Transport Topic Paper

Symmetry Park, Ardley and Land at M40 Junction 10

Tritax Symmetry Ardley Limited and Albion Land Limited

Appendix A Consultee Response to Albion Land

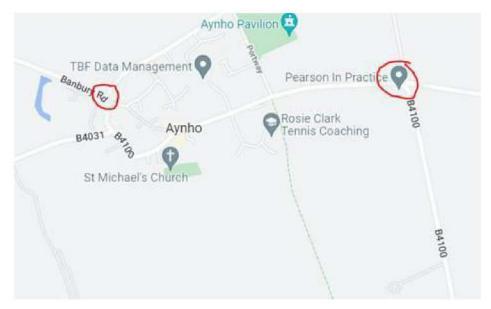
We understand that a Revised Transport Assessment is currently being prepared by the applicant for this site that includes tests via the Bicester Model that should identify other traffic flows than previously assumed and considered.

This is welcomed by the LHA as it has come to our attention that a number of residents in West Northants villages; predominantly those living at Aynho, fear that significant volumes of light traffic associated with this proposed site, will be attracted to using the local highway network through and around these villages. Whilst the LHA are fully aware and supportive of the fact that all taxed and insured vehicles should be able to travel freely on the network, we would request that a data counting exercise be undertaken in order to prove or disprove this suggestion.

The LHA therefore request that the consultant undertake counts of traffic coming from the north / west / east to the site, which will then allow us to consider actual traffic flows affecting Aynho and Croughton villages, which can then be used as base model data for the Bicester Transport Model future year tests and any detailed junction capacity assessments within Aynho that are the concern WNC.

We request that monitoring using manual classified counts be undertaken over three days in three neutral weeks, as detailed on the plan section overleaf, and a report provided to evidence traffic patterns.

Public rights of way

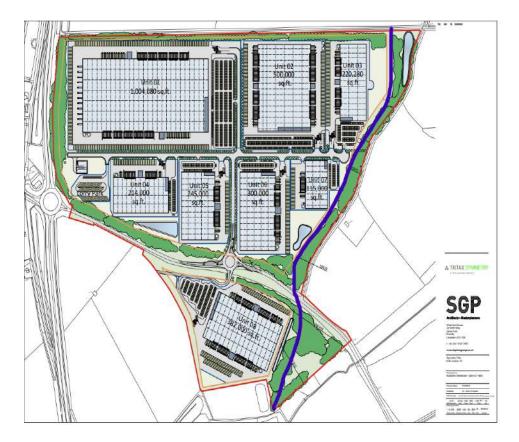
Although this development doesn't have any PRoW crossing the site, two PRoW are immediately adjacent and more are in the vicinity. Standard measures below will apply.

The public rights of way network outside of the site will be placed under much greater pressure as a direct result of this development. This pressure is related to the traffic increase and the change in the attractiveness and amenity of the countryside and PRoW in this area during construction as well as during operations. In short the PRoW become less pleasant to use, the roads are harder to cross or use and the area suffers greater impacts on NMUs

A s106 contribution of around **£400,000** will be requested to allow the Countryside Access Team to plan and deliver improvements with third party landowners in a reasonable time period and under the Rights of Way Management Plan aims. The contribution would be spent on improvements to the public rights of way in the vicinity of the development – in the 'impact' area up to 3/5km from the site, predominantly to the east, south and north. Improvements to existing PRoW may be made to enable easier access, improved signing etc but for this application the focus will be on creating or trying to create an alternative or bypass routes for PRoW to take NMUs away from traffic and operations site impacts across both parts of the site and on the roads. At this stage this could entail seeking the upgrade of footpath to bridleway, creation of entirely new sections of bridleway, works to roads to make them safer for NMUs, along with associated structures, signing, surfaces and signals.
